**SECTION 00 90 04
BIDDING AND CONTRACT REQUIREMENTS
ADDENDUM NUMBER 4**

Issued: October 12, 2023

Re: ADDENDUM NUMBER (4) TO THE BIDDING DOCUMENTS FOR

**McHenry County College
University Center at MCC**
Architect's Project Number: 22-050

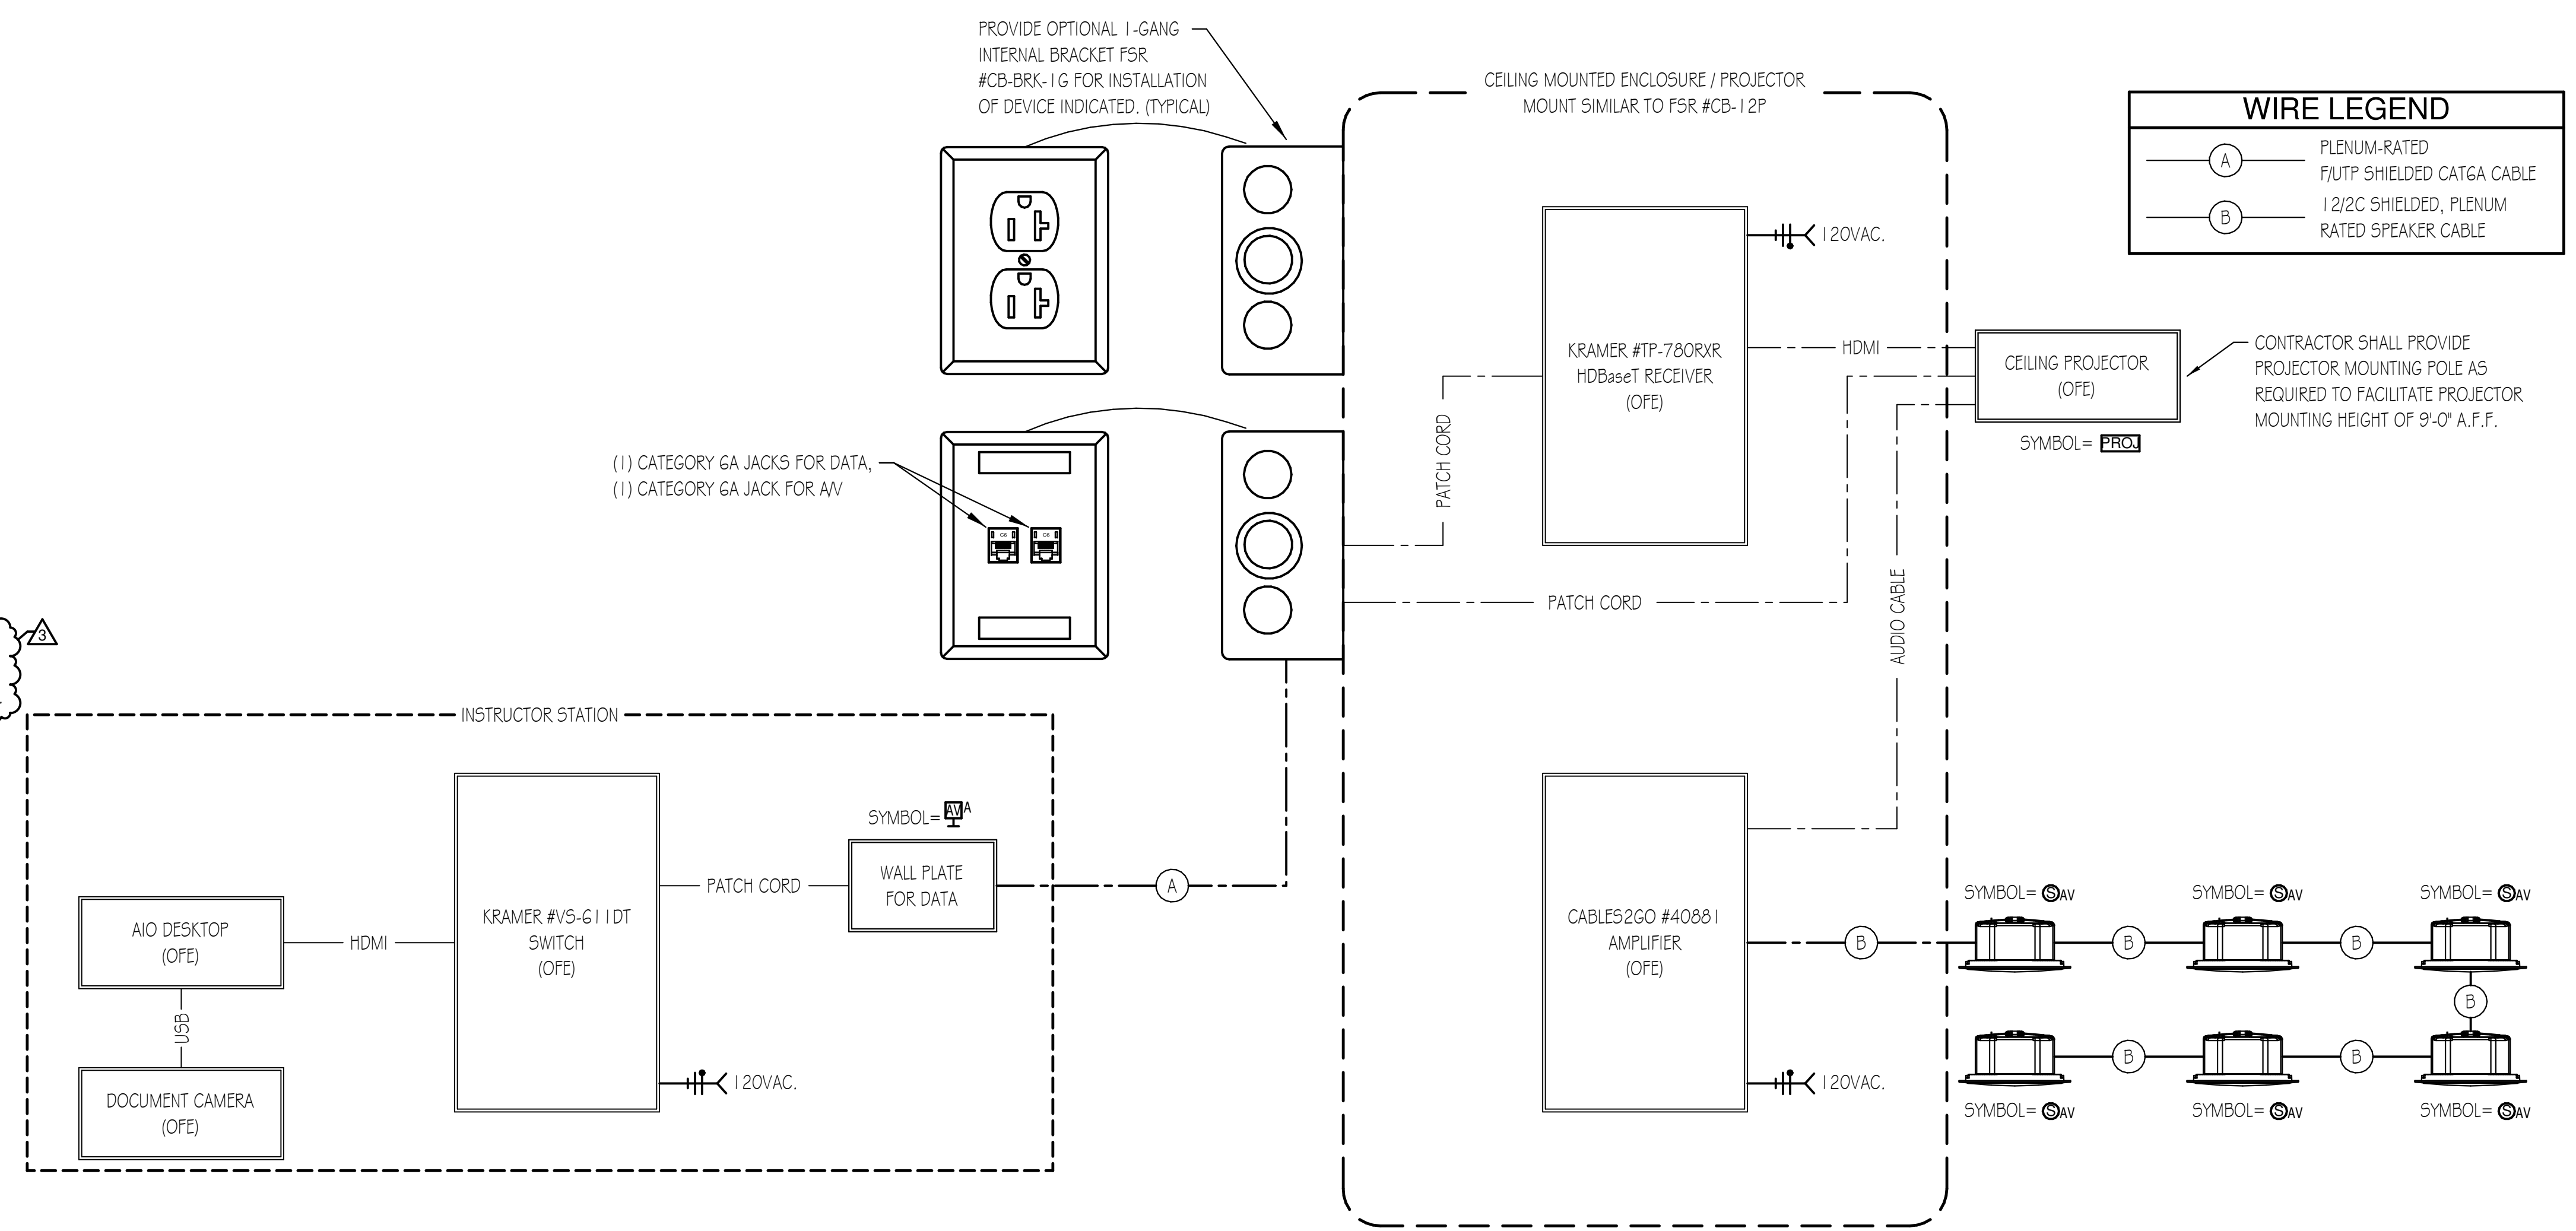
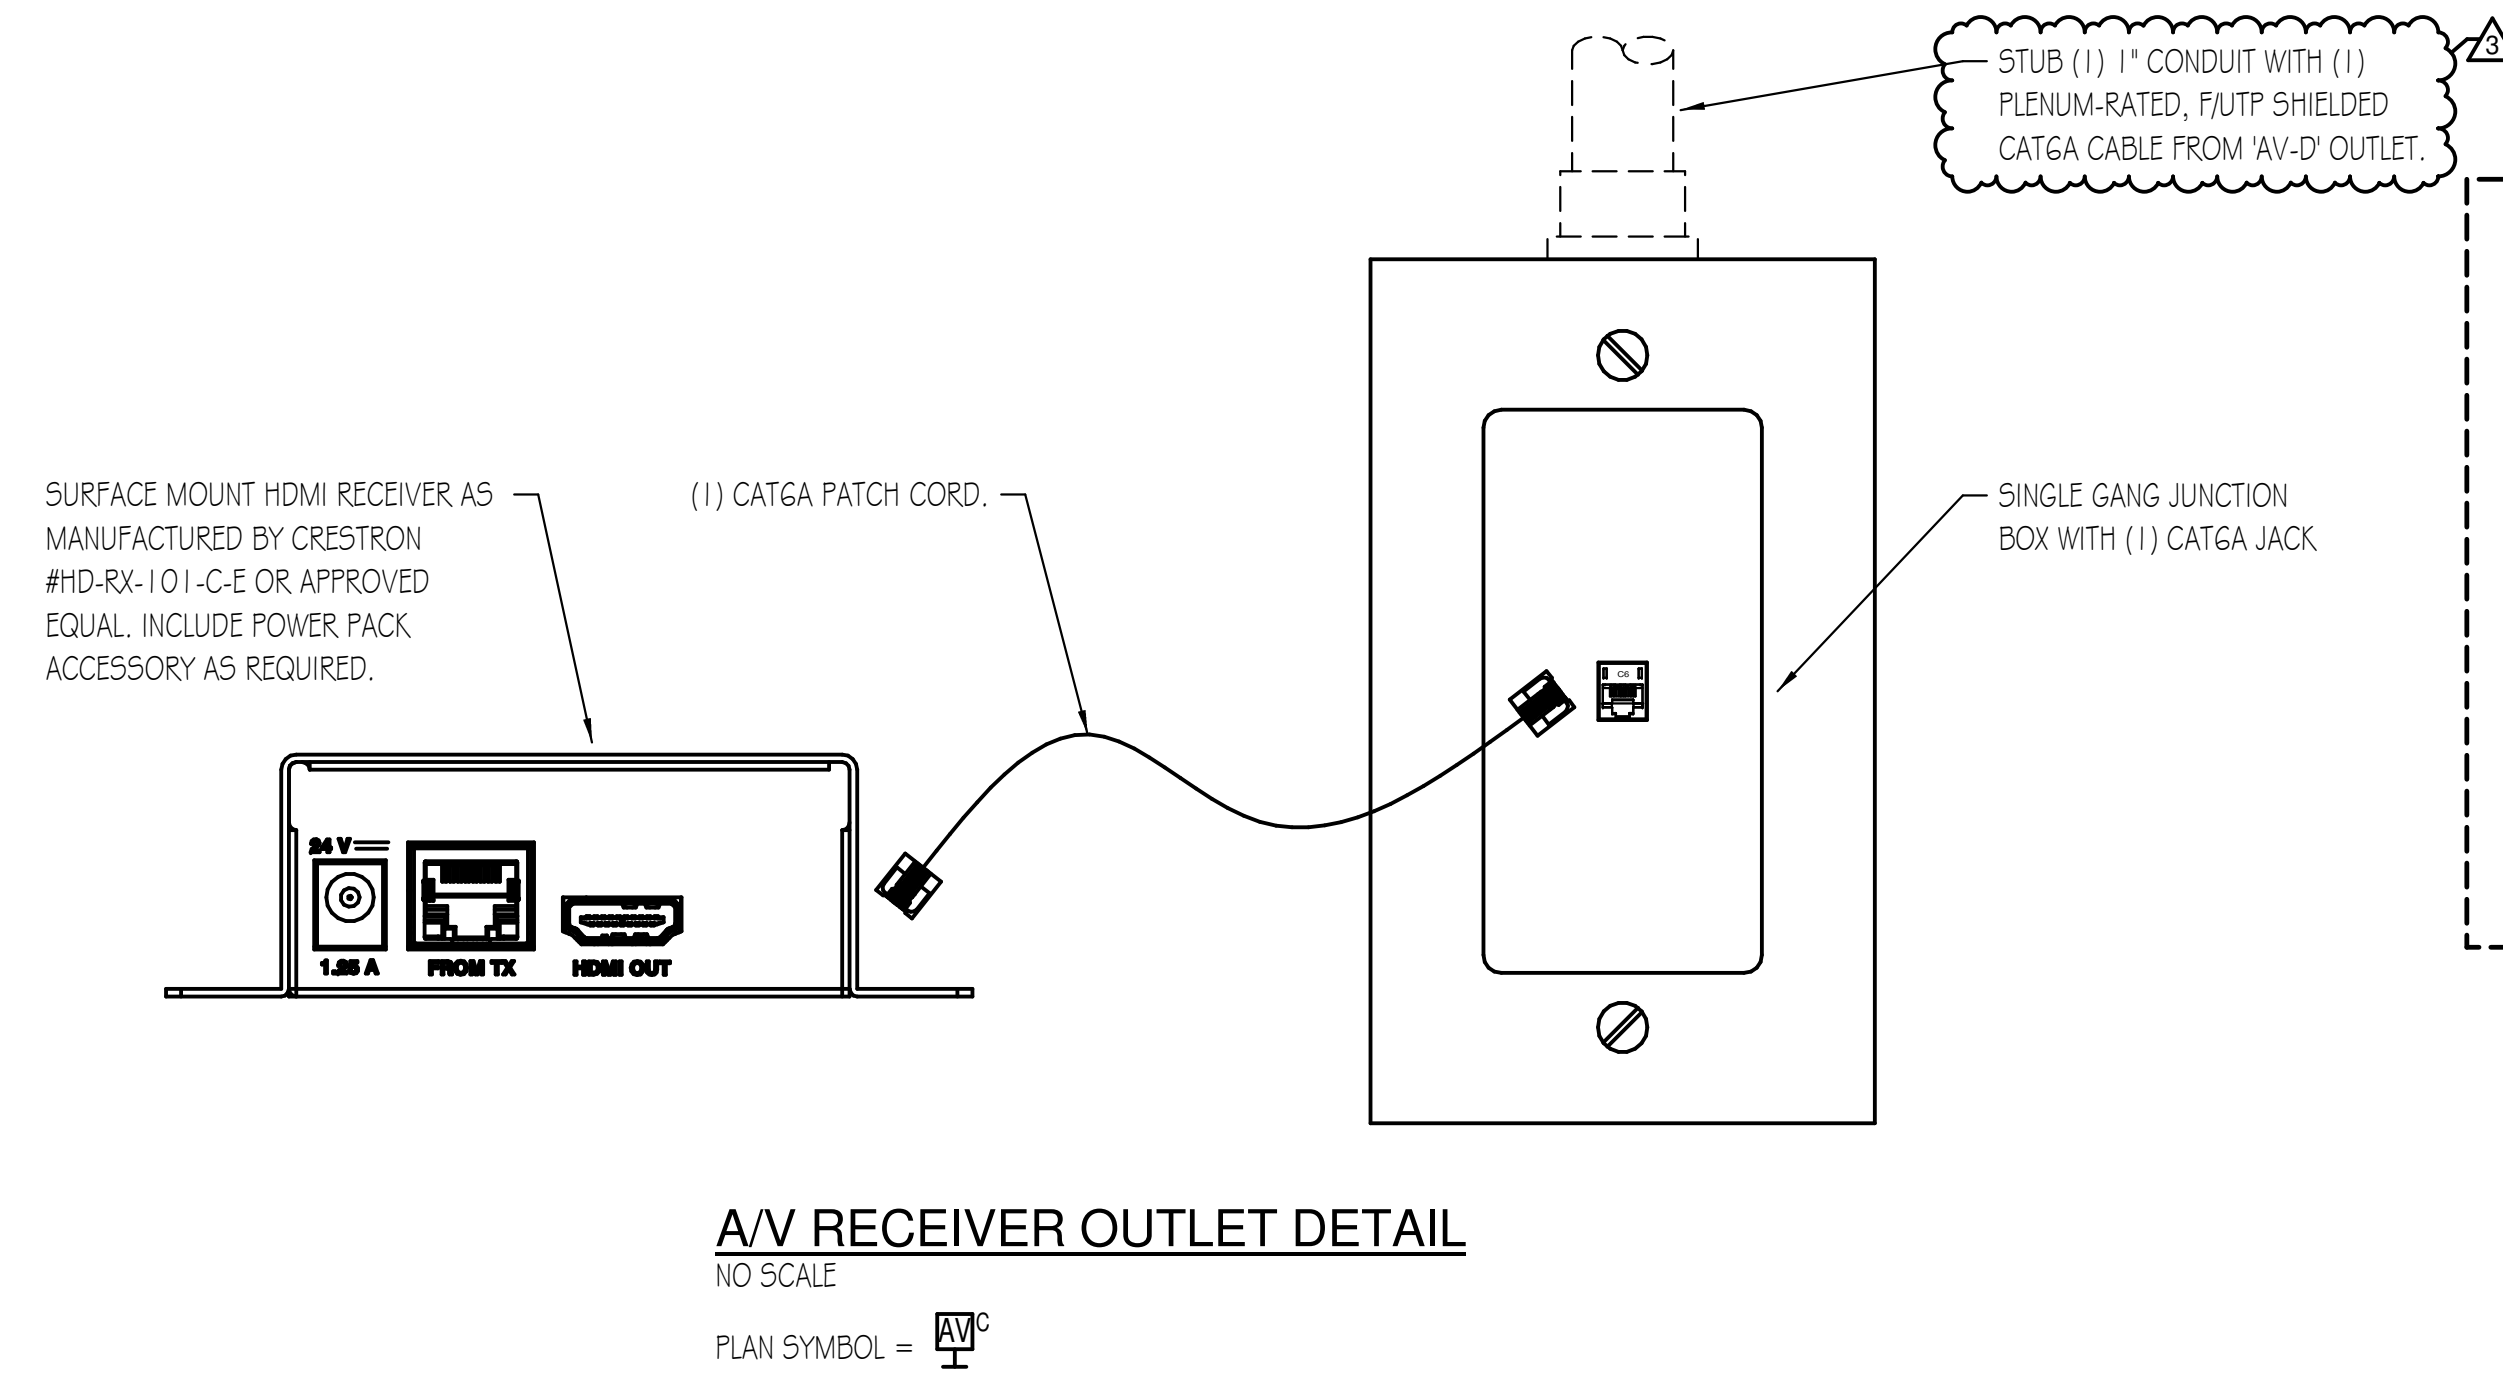
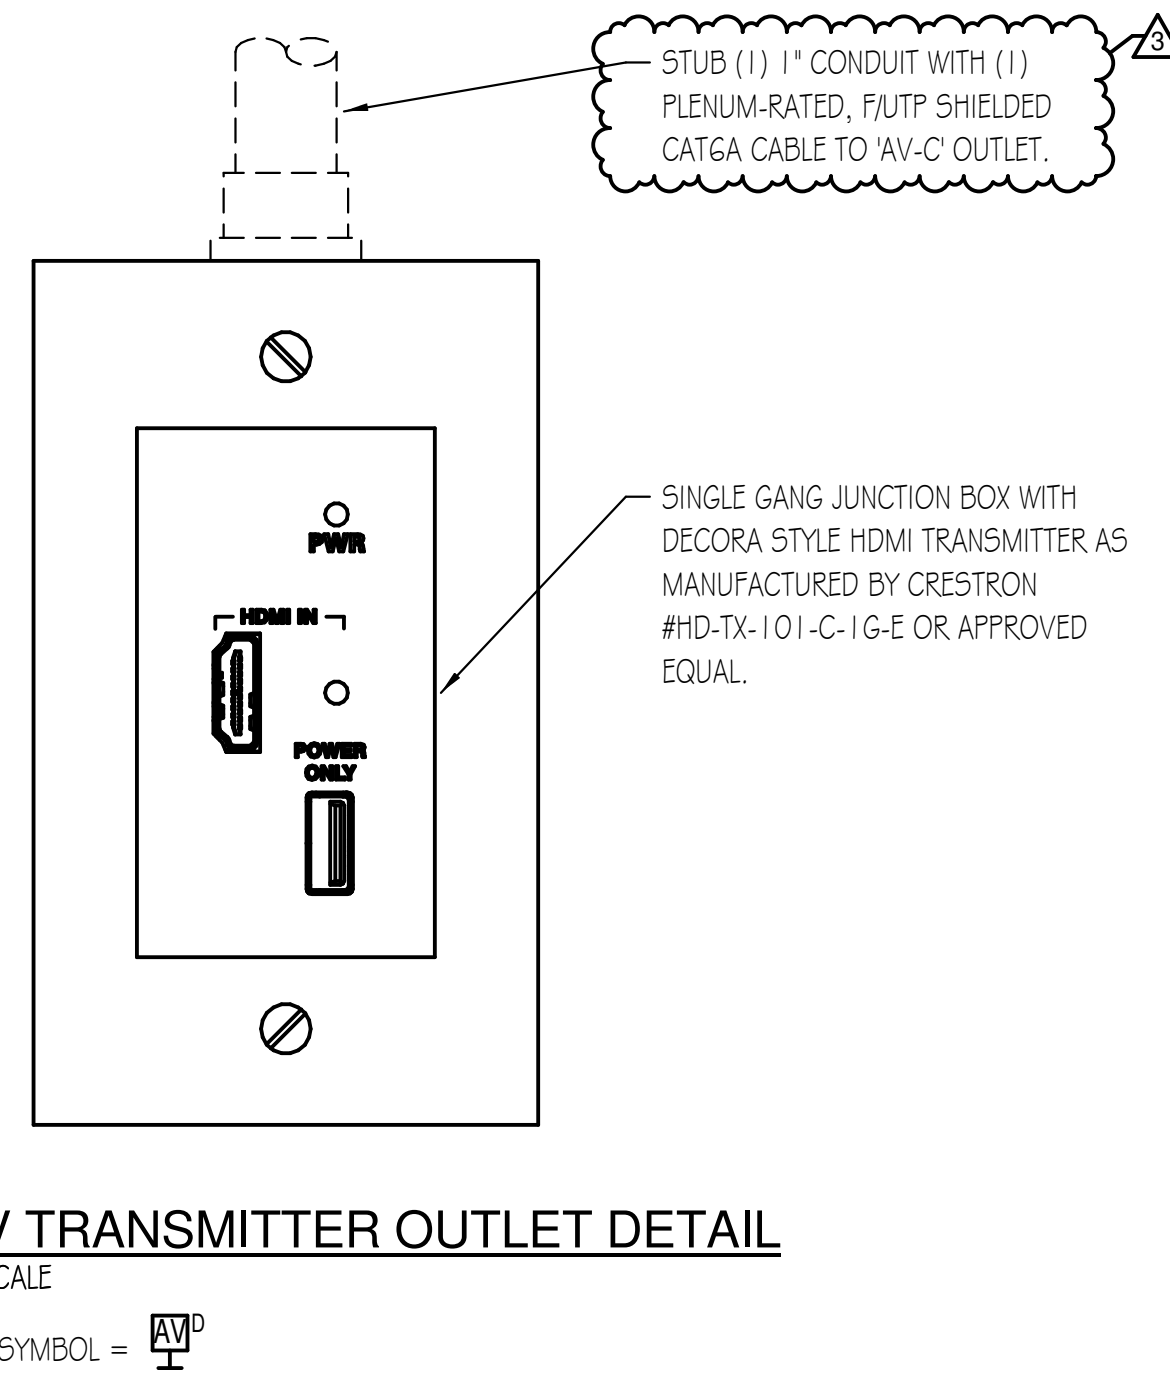
- C. **ADD** note #5 to 'LUMINAIRE SCHEDULE'.
- 5. E7.10
 - A. **REVISE** 'TYPICAL NETWORK RACK DETAIL' to indicate 2" innerduct for routing of fiber optic backbone cable.
- 6. E7.30
 - A. **REVISE** 'A/V RECEIVER OUTLET DETAIL'.
 - B. **REVISE** 'A/V TRANSMITTER OUTLET DETAIL'.
 - C. **ADD** 'A/V OUTLET DETAIL'.
